Bulletin No.: 15777A
Date: January 2016

PRODUCT SAFETY RECALL

SUBJECT: Front Seat Belt Bolt Torque

MODELS: 2015 Chevrolet Cruze

4341406

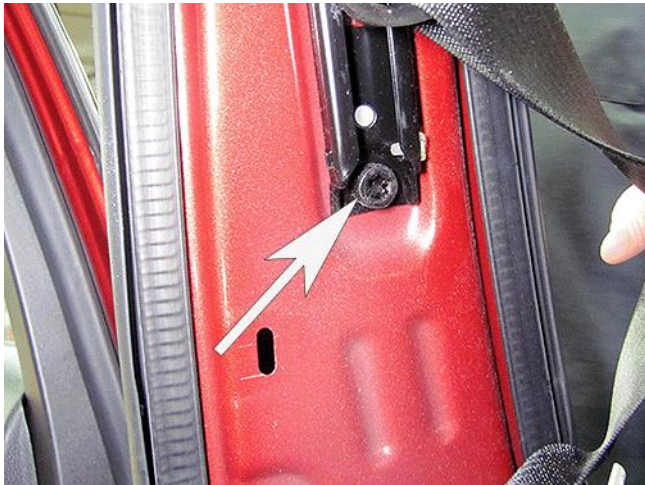
3. Locate the upper front seat shoulder belt guide adjuster bolt, **Tighten 45 Nm (33 lb ft).**

4341411

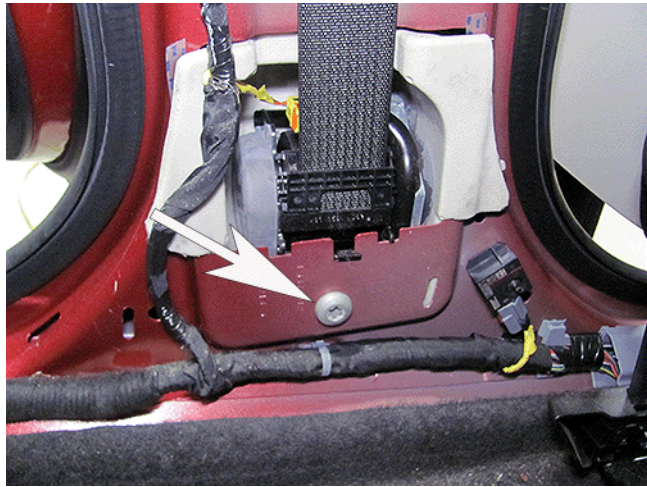
- 5. Locate the front seat belt retractor D ring bolt, **Tighten** 45 Nm (33 lb ft).

- 6. Locate the front seat shoulder belt retractor bolt, **Tighten** 45 Nm (33 lb ft).
- 7. Reinstall the center pillar upper garnish molding. Refer to *Center Pillar Upper Garnish Molding Replacement* in SI.
